Product Change Notification

Product Group: Opto Sensors & IRDC / 05-MAR-2009 / PCN-OSI-302-2009 Rev0

Alternate Production Site for 3mm, 5mm and PLCC2 Opto-Emitter Devices

Attachment to PCN-OSI-302-2009 – Alternate Production Site for 3mm, 5mm and PLCC2 Opto-Emitter devices

A) Illustration of dimensional Changes for 5mm Devices (2 minor changes):

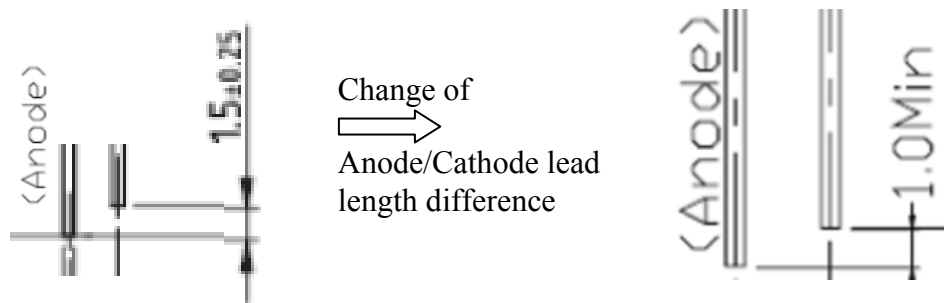
- 1) Dambar width will change **from 1.2mm to 1.1mm** as shown below
